**Commonwealth Edison**  
One First National Plaza, Chicago, Illinois  
Address Reply to: Post Office Box 767  
Chicago, Illinois 60690

March 18, 1981

Subject: Dresden Station Units 2 and 3  
Adequacy of Station Electrical  
Distribution System Voltages  
NRC Docket Nos. 50-237/249

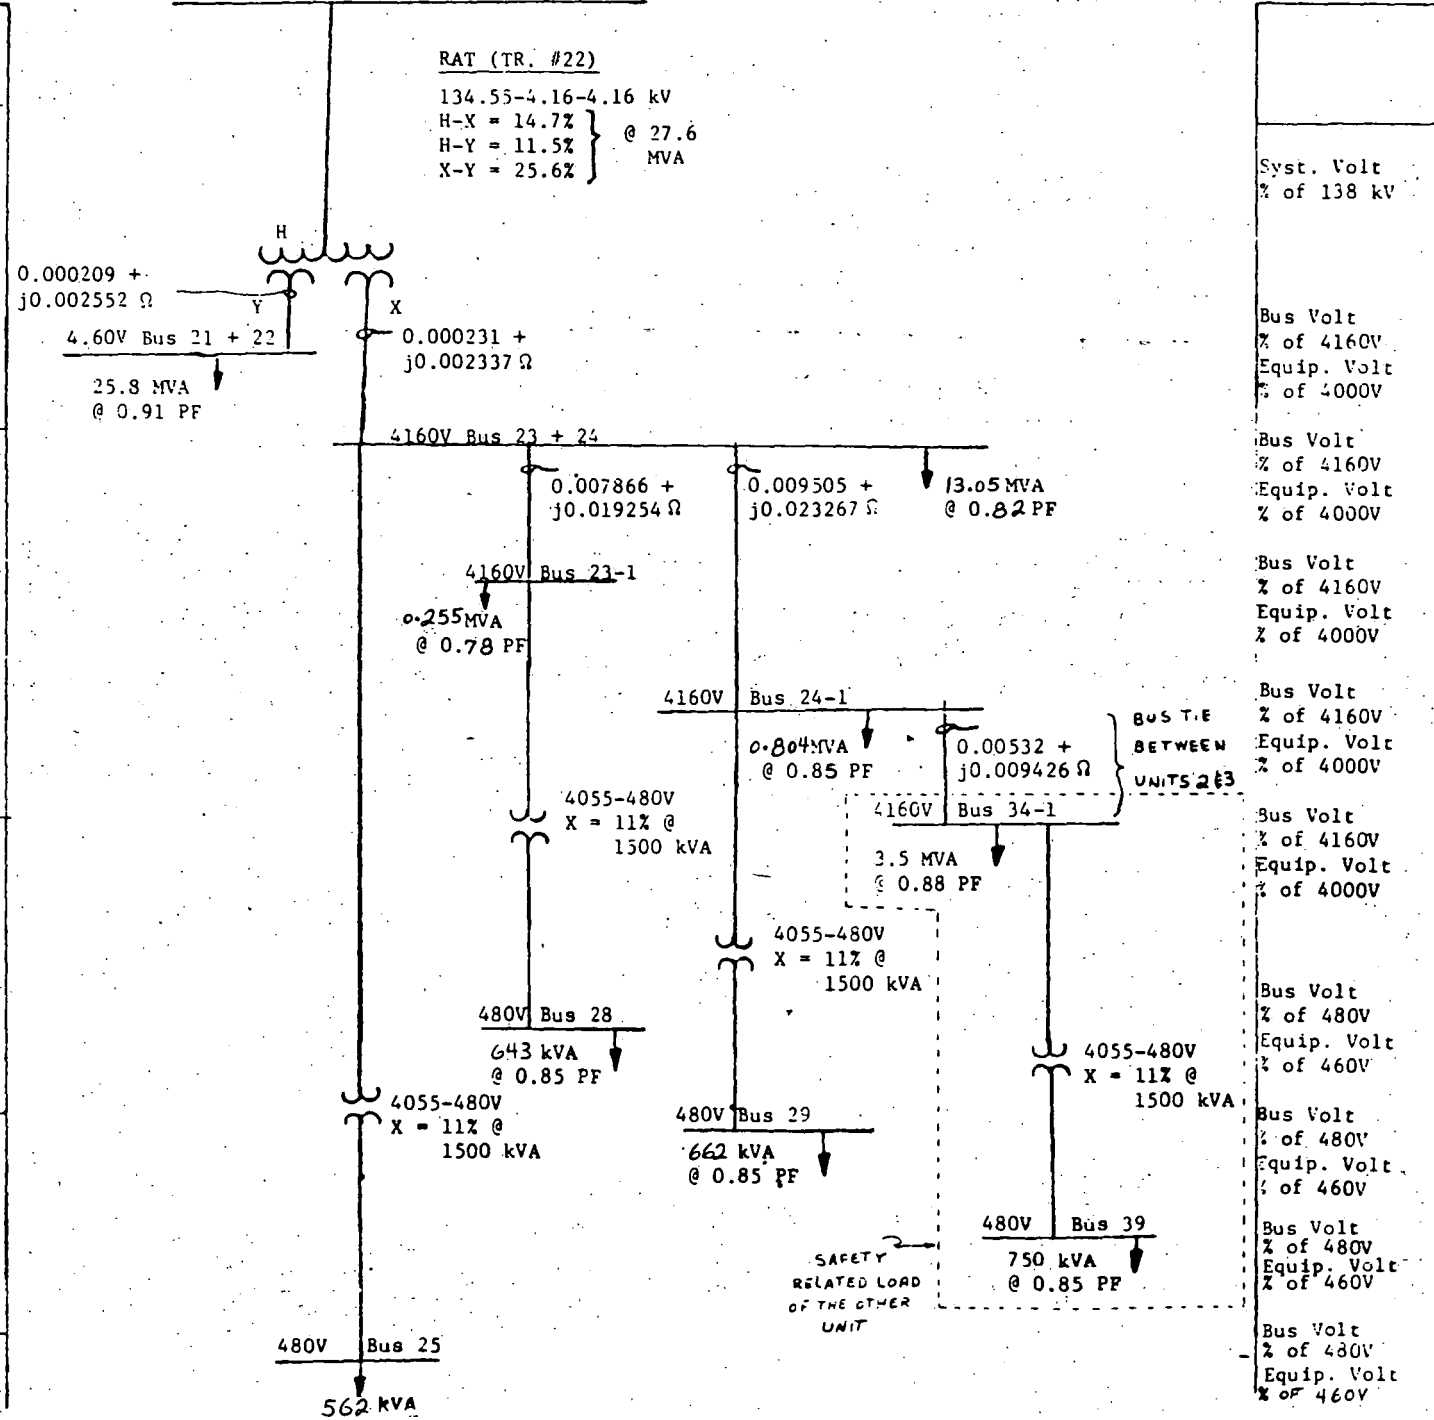
This information is provided in response to an NRC staff question concerning low voltage at equipment terminals for the condition of lowest grid voltage and maximum bus loading for the condition of a Unit 2 trip with the Unit 2 Reserve Auxiliary Transformer 22 carrying the Unit 3 ESF loads.

Attached is a revised table dated 3-11-81 showing the Dresden Unit 2 and 3 auxiliary power bus voltages when Unit 2 Reserve Auxiliary Transformer is carrying the Unit 2 shutdown load and the Unit 3 Essential Service Features load through the intertie between Units 2 and 3.

The difference between this calculation and the one submitted in Reference (a) is that the shutdown load is a realistic load assuming no manual operations to disconnect load after the unit trip.

The voltages at the 460 volt motor terminals were calculated using actual motor feeder impedances. A combination of the largest motor size and longest feeder length on each bus were selected for maximum voltage drop at the load.

The results indicate that the running voltage at all 4000 volt and 460 volt motors is above 90% of motor rated voltage.
